THERMAL PERFORMANCE REVIEW

Multi-Unit Development

55 Milton Street, Mount Hawthorn

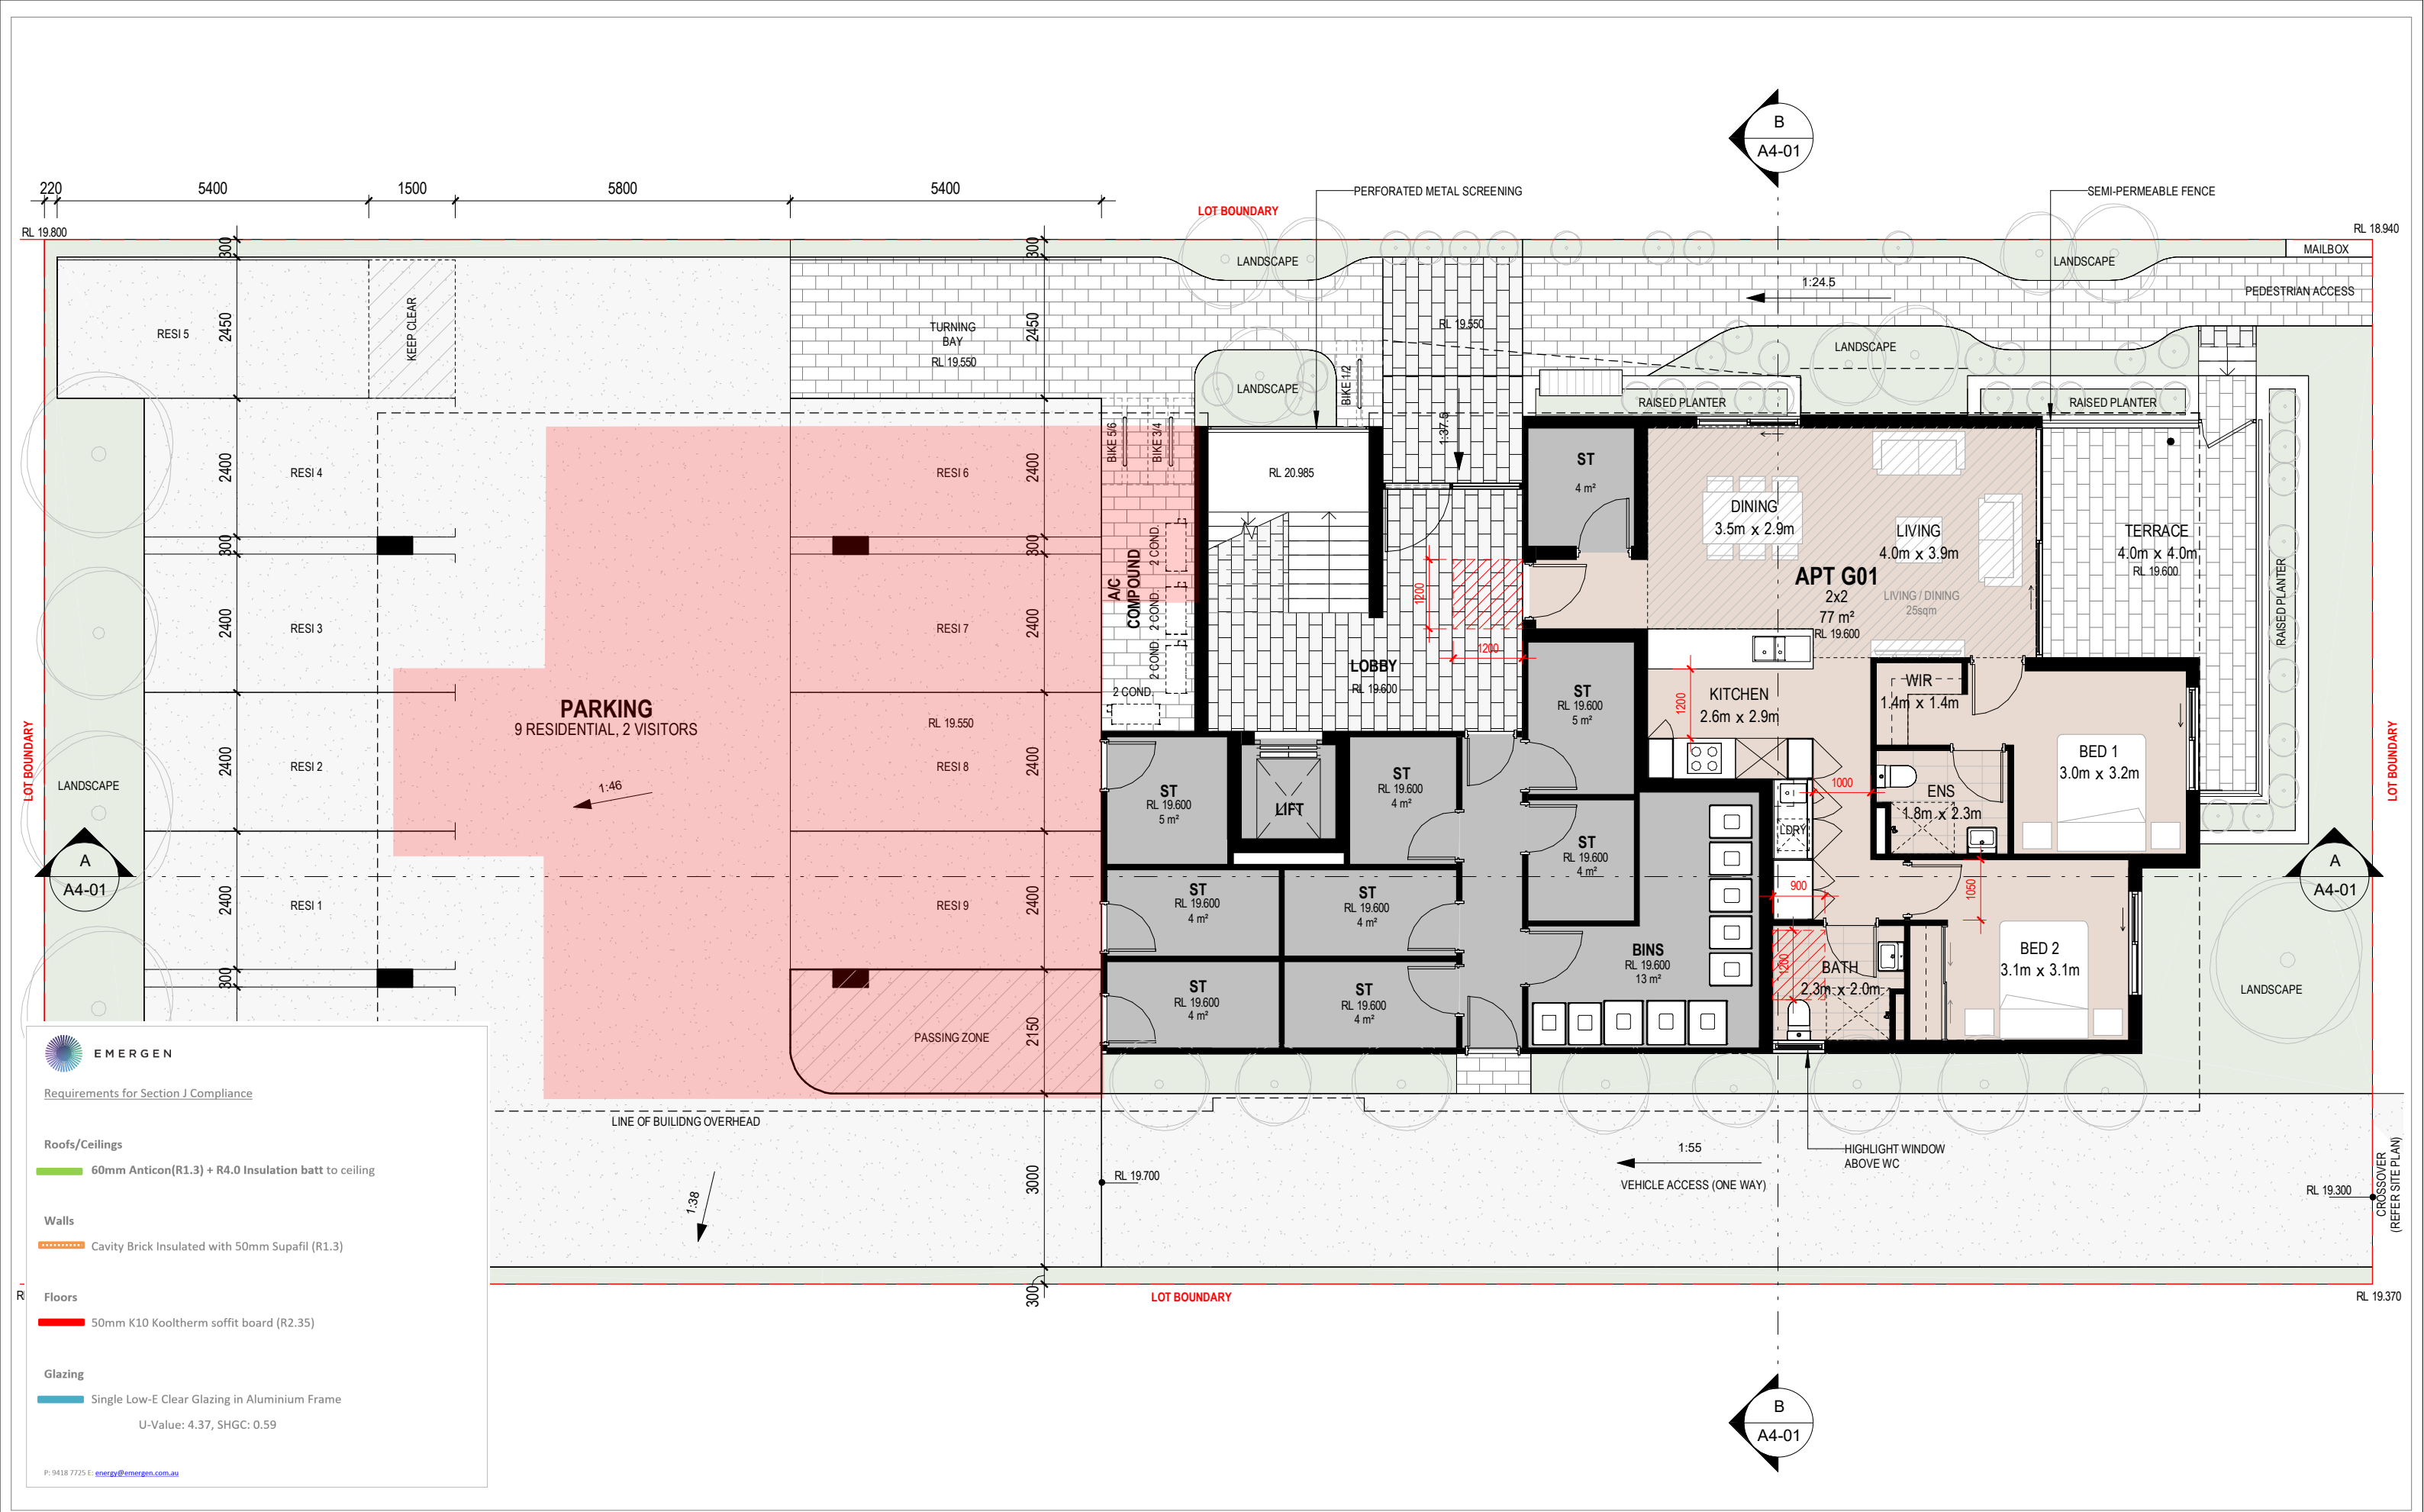
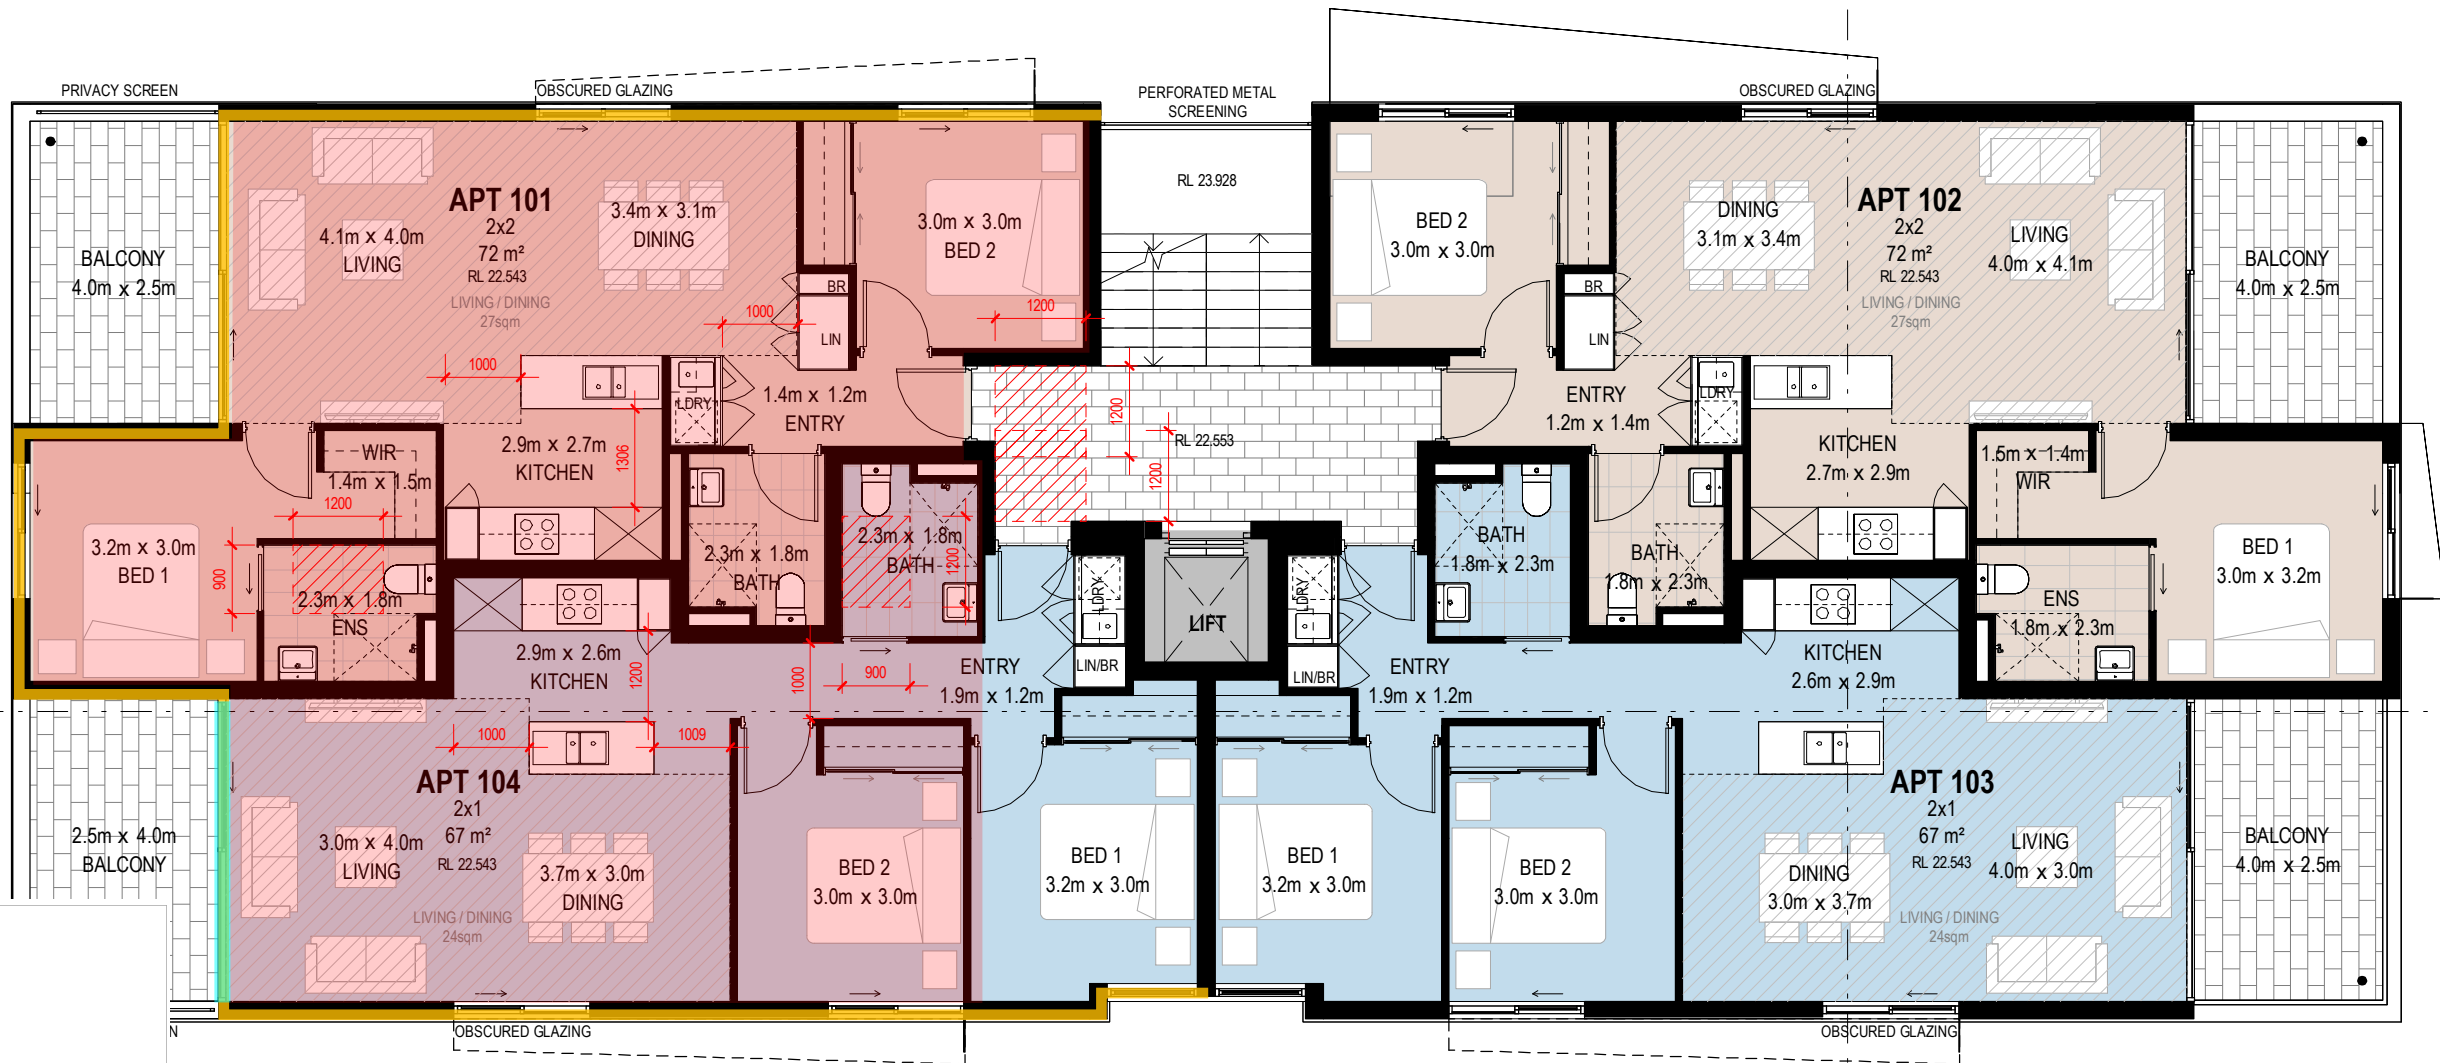
Requirements for Section J Compliance

Roofs/Ceilings

60mm Anticon(R1.3) + R4.0 Insulation batt to ceiling

Walls

Cavity Brick Insulated with 50mm Supafil (R1.3)

Floors

50mm K10 Kooltherm soffit board (R2.35)

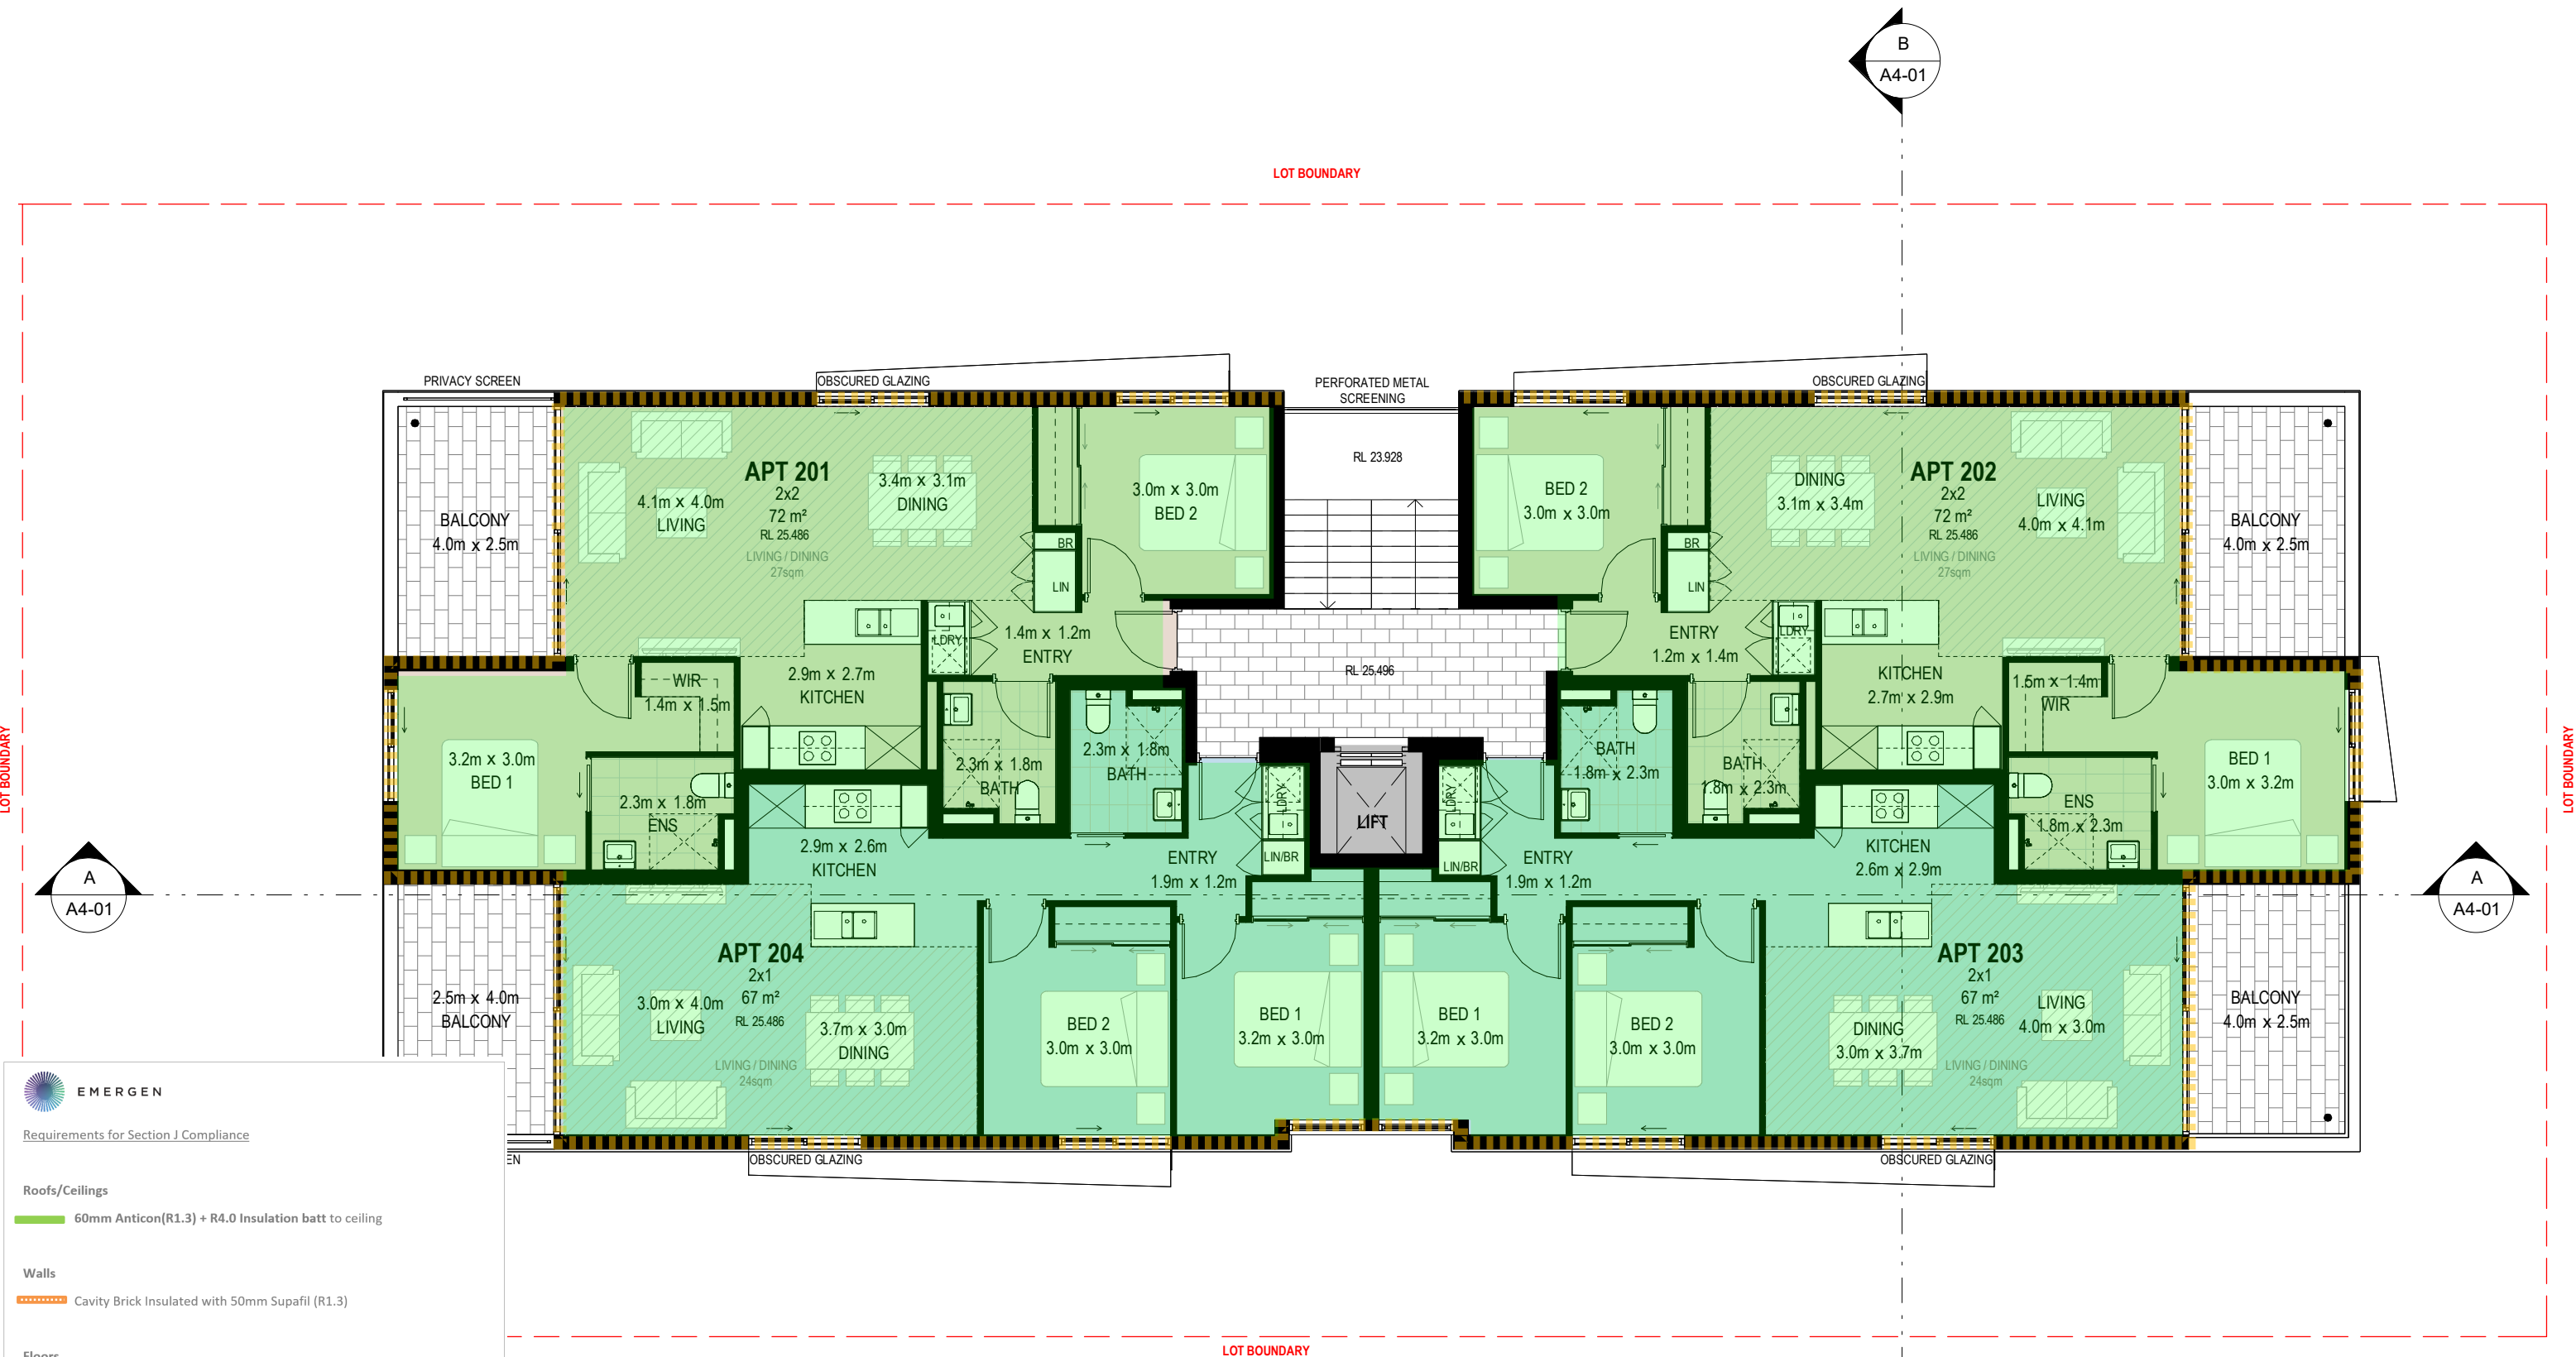
Glazing

Single Low-E Clear Glazing in Aluminium Frame

U-Value: 4.37, SHGC: 0.59
